STAFF REPORT: 9/13/2023 REGULAR MEETING

APPLICATION NUMBER: #23-8515

ADDRESS: 3515 SHERBOURNE

SCOPE: DEMOLISH ADDITION, ERECT REAR DECK, REPLACE WINDOWS, REPAIR DRIVEWAY, PAINT TRIM (WORK COMPLETED WITHOUT APPROVAL)

FLOOR 1: 1,385 sq.ft. FLOOR 2: 1,360 sq.ft. FLOOR 3: 1,171 sq.ft. FLOOR 4: 759 sq.ft. TOTAL: 4,675 sq.ft.
 Floor plan 1, by realtor.com, orange highlights by Staff showing former locations of 13 steel casements replaced by current owner at the rear (south) and side (east and west) elevations.

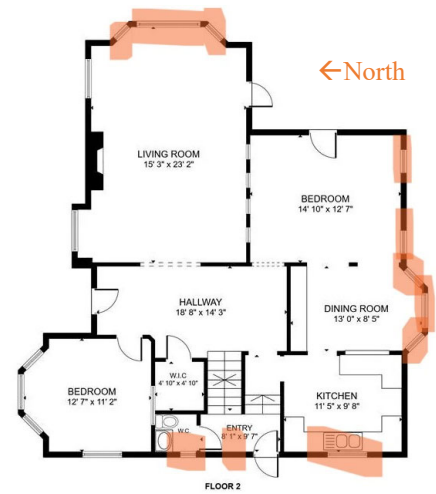
- Staff found no record of the replacement history of windows for this property other than those replaced by the current owner. Staff has not received a full assessment of all the windows and their conditions. Staff reviewed historic designation, preceding street-view and real estate images, and concluded that all windows have been replaced, except for those done by the current owner, by April 2023. It may be possible that many of these non-historic windows were in place prior to historic designation. Since April 2023, and prior to the current owner's actions, the only remaining historic windows that remained were the steel casements that were replaced by the owner without approval. Currently, it appears that all original windows have been replaced with vinyl, aluminum, or glass block windows.

- Staff confirmed with the owner that the replaced steel casements were disposed and not stored or salvaged.
- The owner states that these 13 remaining steel casements windows, located at the rear and side elevations, had broken glass, missing parts and were inoperative. However, staff did not receive any photographic

evidence or statement from an architect or window specialist. Staff did observe that the windows appeared to be in place and in fair condition from real estate images, but not able to view any particular details as stated by the owner, in these images. (See site photos 4-8 and floor plan 1)

- It is staff's opinion that these 13 remaining steel casement windows with true divided light are distinctive, character-defining features of the house that were remaining examples of the window expression for this English Revival home that were removed without approval.
- The proposed operation, configuration, vinyl material, between the glass grids and glass tint color have no resemblance to the original casement windows and are not appropriate.

- No documentation establishing that the original condition of the casement windows were beyond repair was submitted or available.
- The replacement of steel casement windows with vinyl, double-hung windows is inappropriate as they introduce a material and design that alters the historic character of the property, remove distinctive features, and does not match the character-defining feature of the original divided light casements in design, texture, material, or operation.

- No documentation establishing that the original condition of the casement windows were beyond repair was submitted or available.
- The replacement of the casement windows with vinyl, double hung windows is not compatible with historic architecture in the house in that they:

- destroy the distinctive, character-defining features of the original remaining windows, particularly the true-divided lights and steel casement detailing,

- introduce a new operation, configuration, design and scale,
 - introduces a new material, vinyl, which is not an appropriate material for windows.
- Removing the foundation plantings drastically alters the appearance and features of the historic property, and exposes utilizes and other features that were previously screened.
